# Access Compliance Report

## Public Rights-of-Way

Intersection ID: 11285	Main Street: AVENSONG_CROSSING_DR	Cross Street: CHANTRESS_LN	Location: NW
ADA ID: D38C0869FCA8	Ramp Type: BlendTrans1	Initial Pass/Fail: Fail	Overall Compliance: No
Severity Score: 8.75			
Codes/Mitigation Info/Possible Solution		Field Measurements/Component Compliance

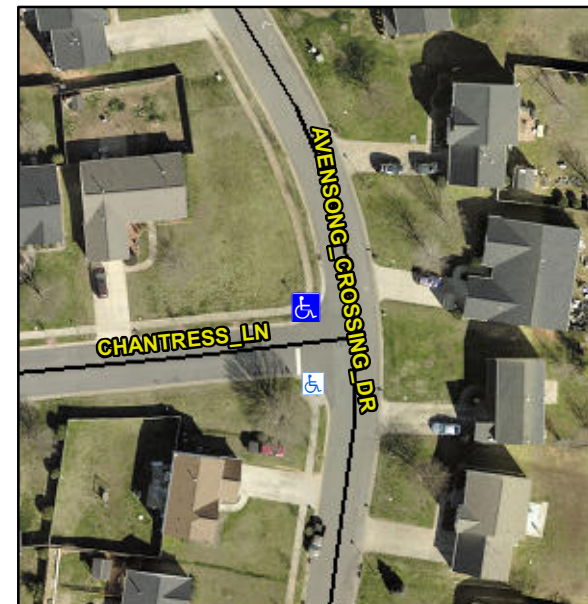
**Not Found, R304.5.1**

Compliance	Description	Data	Compliance	Description	Data
N/A	Ramp Length (in)	45.5	Yes	BlendTrans Slope (%)	4.5
No	Ramp Width (in)	38.5	Yes	BlendTrans XSlope (%)	0.2
N/A	Flare Type LT	N/A	N/A	Flare Type RT	N/A
N/A	Flare Slope LT (%)	N/A	N/A	Flare Slope RT (%)	N/A
N/A	Flare Traversable LT?	N/A	N/A	Flare Traversable RT?	N/A
N/A	Landing Length (in)	N/A	N/A	DWS Provided?	N/A
N/A	Landing Width (in)	N/A	N/A	DWS Contrast?	N/A
N/A	Landing Slope (%)	N/A	N/A	DWS Length (in)	N/A
N/A	Landing X Slope (%)	N/A	N/A	DWS Full Width?	N/A
N/A	Landing Curb? (Y/N)	N/A	N/A	DWS Offset (in)	N/A
N/A	Shared Landing?	N/A			
N/A	Gutter Ponding?	N/A	N/A	Gutter Slope (%)	N/A
N/A	Gutter Lip Ht (in)	N/A	N/A	Gutter X Slope (%)	N/A
N/A	Painted X Walk1?	No	N/A	Painted X Walk2?	N/A
	X Walk 1 Direction	To S		X Walk 2 Direction	N/A
	X Walk 1 Width (in)	N/A		X Walk 2 Width (in)	N/A
	X Walk 1 Slope (%)	1.5		X Walk 2 Slope (%)	N/A
	X Walk 1 X Slope (%)	0.2		X Walk 2 X Slope (%)	N/A

N/A	Ramp inside XWalk1?	N/A	N/A	Ramp inside XWalk2?	N/A
	Road Slope (%)	0.2		Clear Space?	N/A
	Road X Slope (%)	1.5	N/A	Clear Space to XWalk (in)	N/A
N/A	Any Obstructions?	N/A	N/A	Storm Grate/Utility Hazard?	N/A
	Obstruction Type			Storm Grate/Utility Type	
		N/A			N/A
			Yes	Surface Condition? (G/P)	Good
			No	Curb Slope (%)	9.9

**Remove & Replace Curb Ramp With Two New Directional Ramps or Equivalent.**
